**SUBDIVISION
PLANNED UNIT DEVELOPMENT,
& ZONING AMENDMENT
STAFF REPORT****March 1, 2018****NAME**

Atchison Place Subdivision

921 Dauphin Street & 926 Conti Street
(North side of Conti Street, 203' ± East of Common Street
extending to the South side of Dauphin Street, 285' ± East
of Common Street).

SITE PLAN

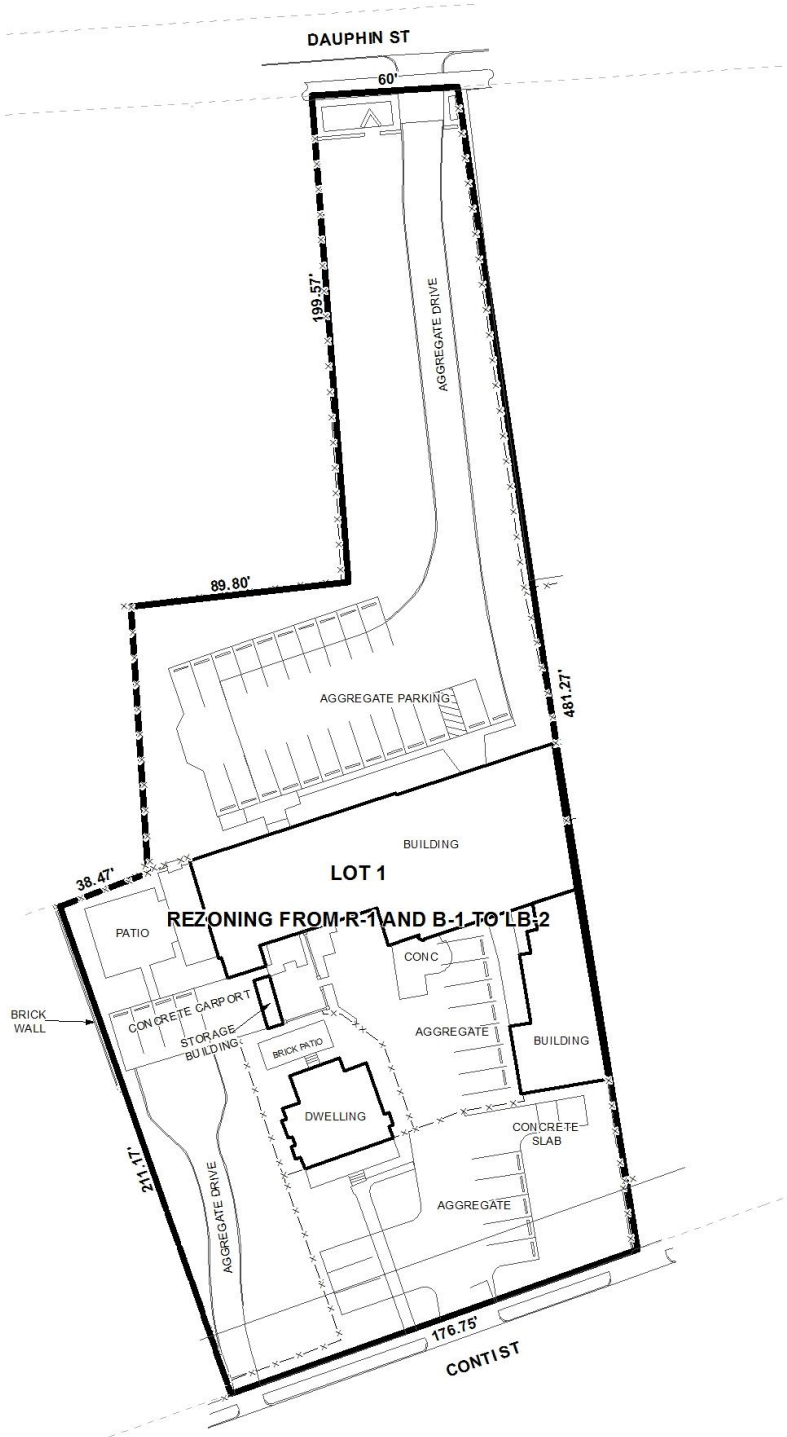
With regards to parking requirements, a total of 41 parking spaces are required based on the breakdown of usage for the building in square footage and dwelling units. There are 21 parking spaces required for the residential portion of the site, 10 parking spaces required for the retail/ furniture, and 10 for the office space. The parking chart provided on the site plan states there are 40 parking spaces, however the site plan depicts a total of 42 spaces, but 3 of the 42 spaces do not have bumper stops (though there may be proposed curb). The site plan chart should be revised to depict the total number of parking spaces to be 42 as proposed and 41 as required as well as add 3 additional bumper stops or clearly indicate if a concrete curb-will be used. It should also be pointed out that the two proposed accessible spaces will need to be paved with a material that meets accessibility requirements.

As proposed, the site plan depicts aggregate surfacing, substandard access and maneuvering. The request to allow existing aggregate parking, access/ maneuvering and surfacing to remain on much of the overall site as well as substandard parking lot lighting are the subject of variances that have been submitted to the Board of Zoning Adjustment, and are scheduled to be considered at the March 5, 2018 meeting. The applicant does not wish to pave the parking lot nor do they want to provide the required levels of parking lot lighting at the minimum 0.5 foot candle throughout the parking area.

There is no dumpster illustrated/ labelled on the site plan. If approved, the site plan should be revised to illustrate all existing and proposed dumpsters, with any new dumpsters to be in compliance with Section 64-4.D.9. of the Zoning Ordinance. If no dumpster will be used on the site, such should be noted on the PUD site plan.

The 25 minimum building setback lines do not appear to be labeled or identified on the preliminary plat or the site plan. Both the plat and the site plan should be revised to clearly depict and label the 25' minimum building setback lines along Dauphin Street and Conti Street, on both the plat and site plan.

- 1) revision of the site plan to depict and label the 25' minimum building setback line along Dauphin Street and Conti Street;
- 2) revision of the site plan to depict the minimum right-of-way width along Dauphin Street and Conti Street;

- 3) revision of the site plan to depict the required number of parking spaces as 41 and the proposed parking spaces as 42;
- 4) revision of the site plan to depict bumper stops in front of all parking spaces or label concrete curbing;

- 5) revision of the site plan to depict compliant paved parking for the 2 accessible parking spaces;
- 6) revision of the site plan to depict/ label a dumpster in compliance with Section 64-4.D.9. of the Zoning Ordinance or add a note that dumpsters will not be used;

- 7) retention of the lot size in square feet and acres;
- 8) placement of a note on the site plan stating the lot is limited to the 2 existing curb-cuts to Conti Street and 1 existing curb-cut to Dauphin Street with the size, design and location to be approved by Traffic Engineering and comply with AASHTO standards;

- 9) placement of a note on the site plan stating tree and landscape compliance will be maintained at existing levels;
- 10) full compliance with parking access/ maneuvering and surfacing as well as complaint parking lot lighting will be required if the variance requests are denied;
